27 February 2002  
AGE-NC Project No. 99-0556

**Subject: Subsurface Investigation Work Plan Addendum - Well Location  
Former Continental Volvo  
4030 East 14<sup>th</sup> Street, Oakland, California**

SITE PLAN - WELL LOCATIONS  
 FORMER CONTINENTAL VOLVO  
 4030 EAST 14th STREET  
 OAKLAND, CALIFORNIA

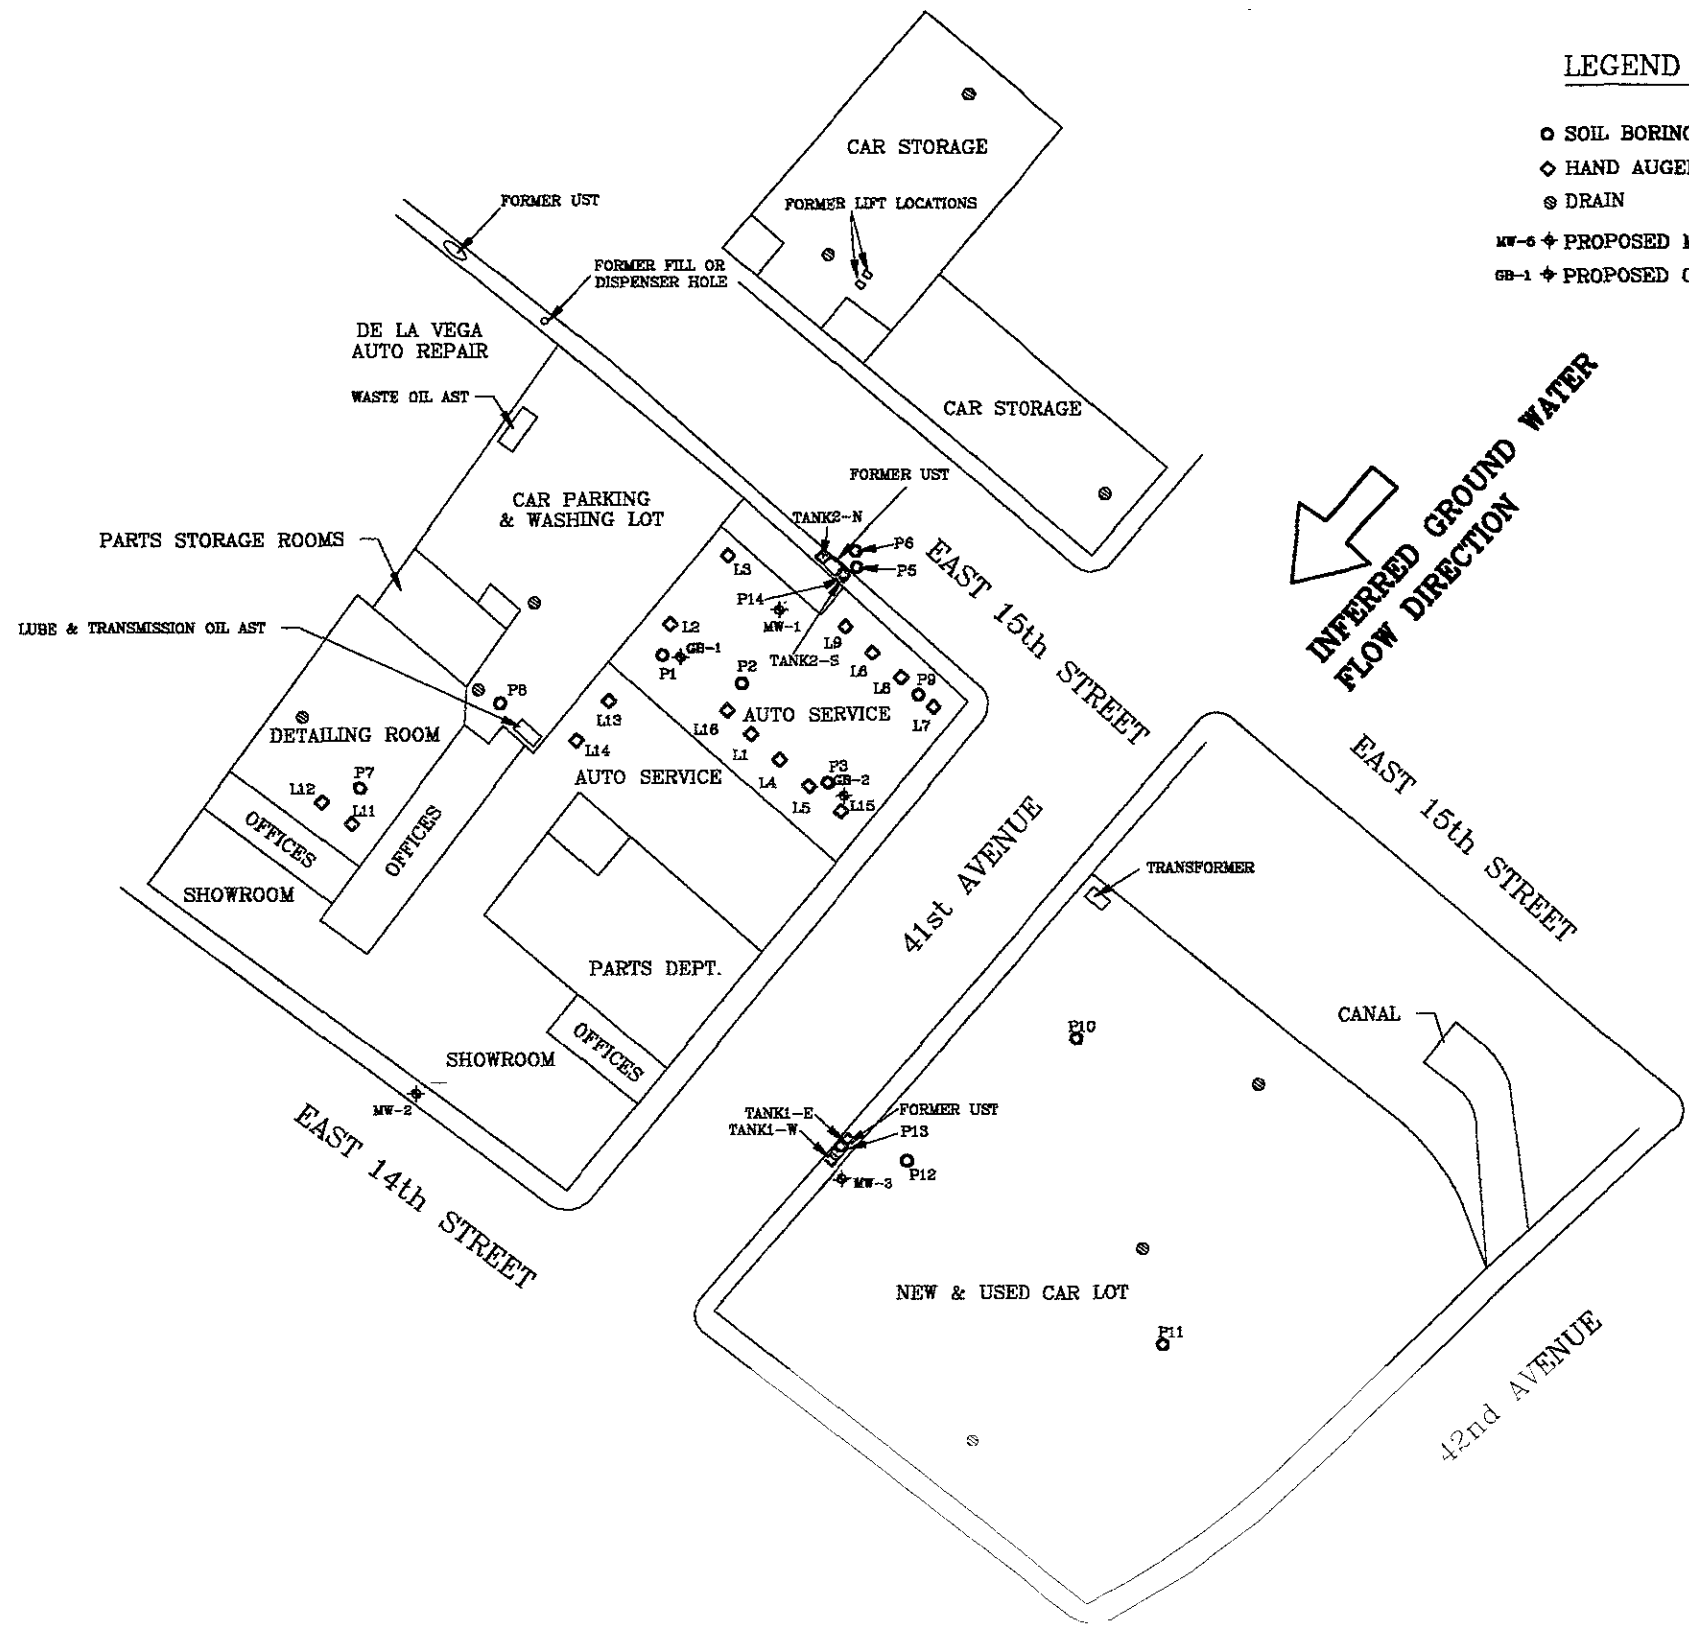
AGE will install three ground water wells. Monitoring well MW-1 will be immediately down-gradient and MW-2 will be approximately 200 feet down-gradient from the former waste oil UST. MW-3 will be located at the former heating oil UST. In addition, grab ground water samples will be collected at two specified locations in the auto service area. The modified locations of the wells and soil boring locations are depicted on Figure 2.

The work plan was unspecific in regards to the total depth of the ground water wells. However, based on previous soil probe borings advanced at the site, the known depth to water is approximately 40 feet bsg. Therefore, AGE proposes to completed the soil borings at 45 feet bsg and install a ten-foot screen interval as described in the work plan.
